AE 4180 Front panel PCB inner side
Modification for 40/40 Channels

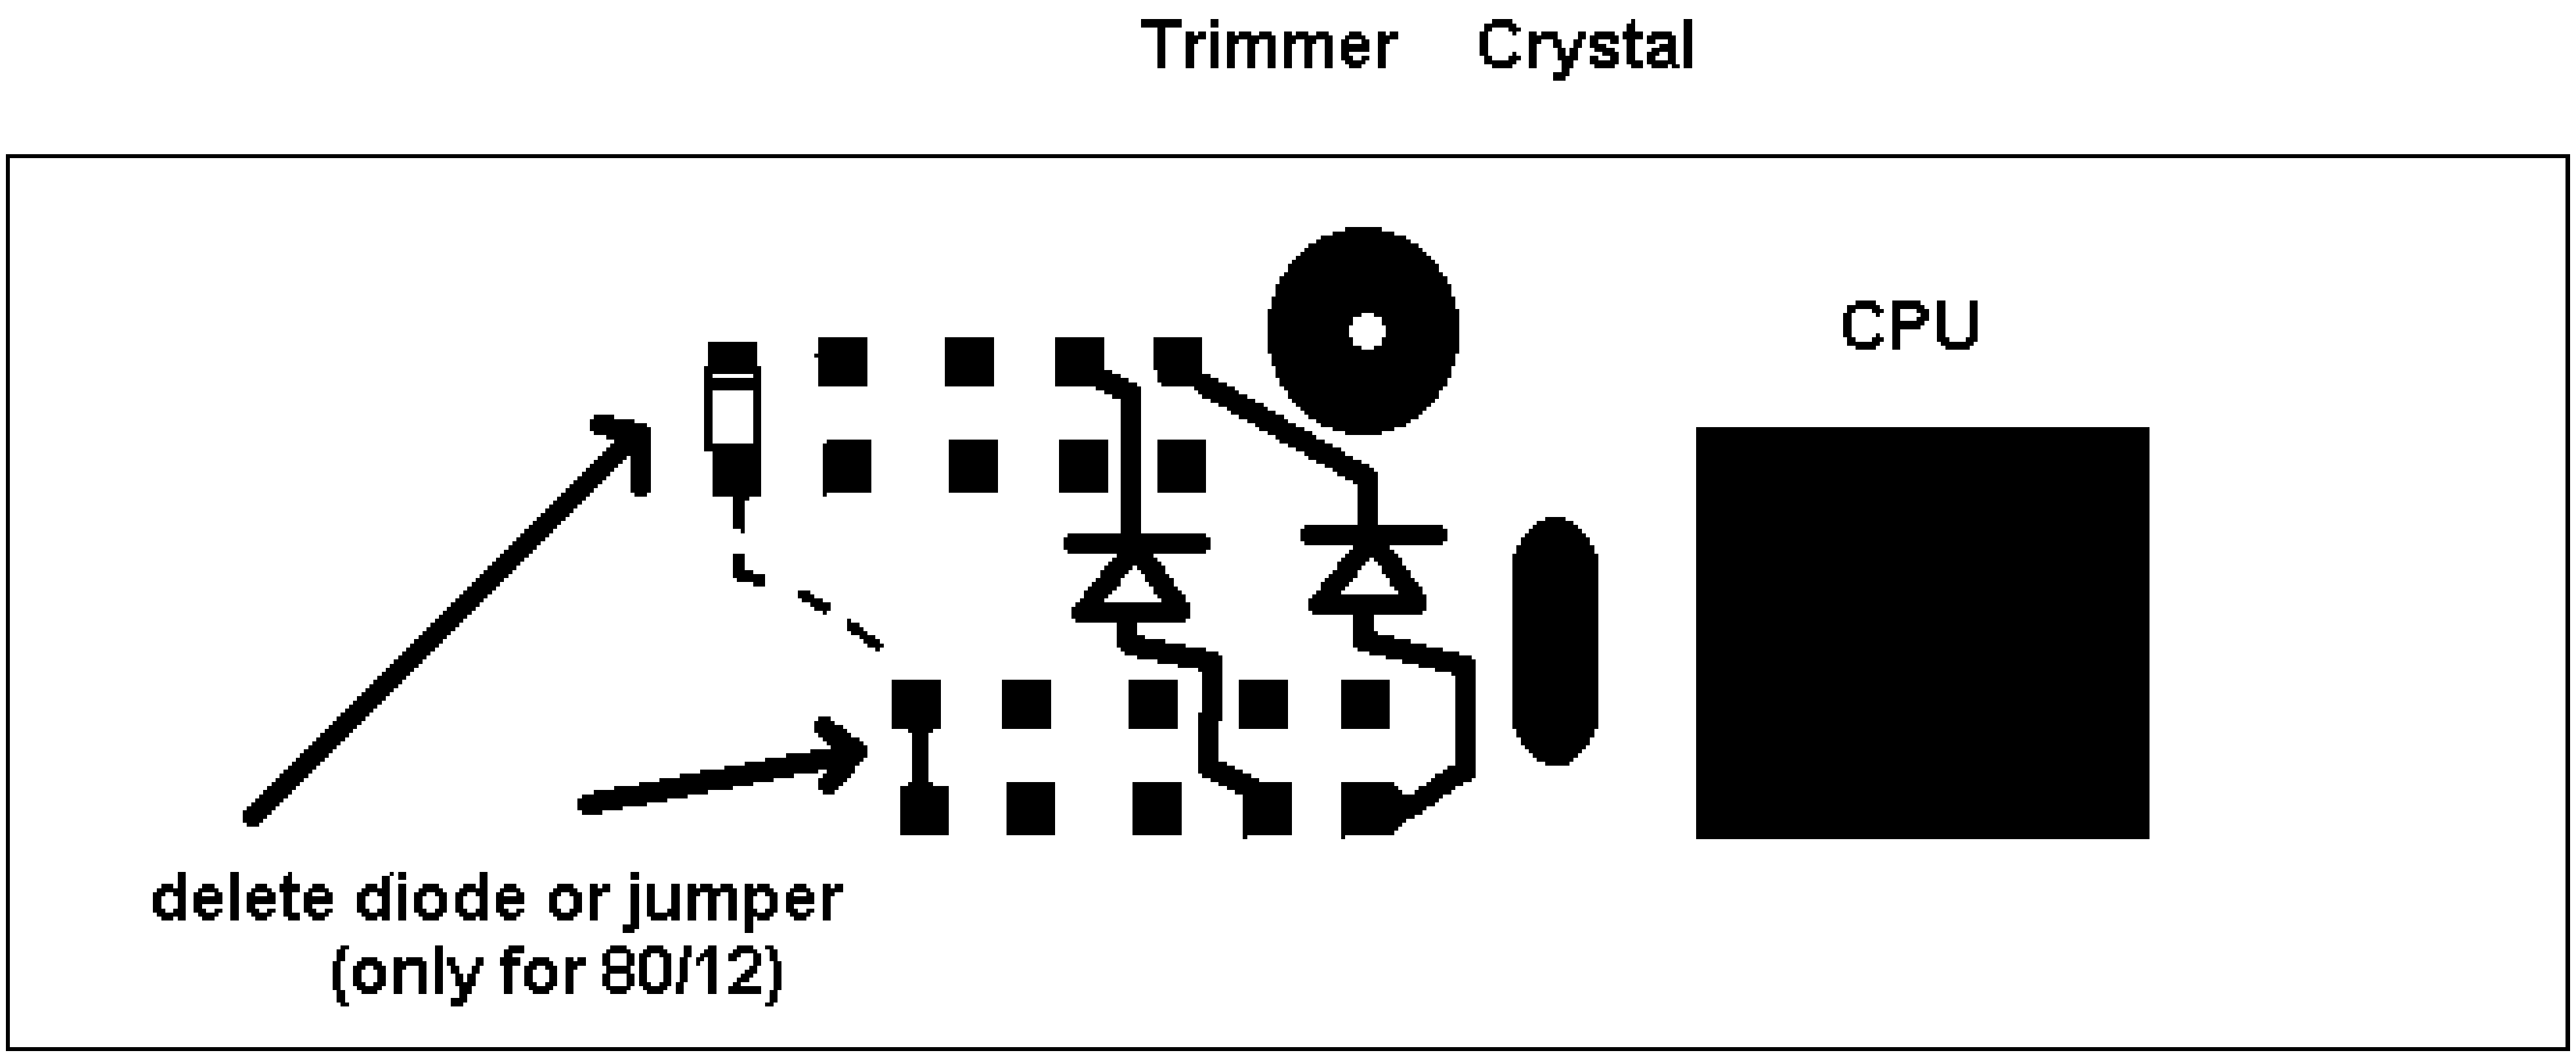
Additional Diodes (2 x 1 N 4148) for 40 CH AM+FM

This drawing is valid only for AE 4180
Diode positions are different from AE 4100 !
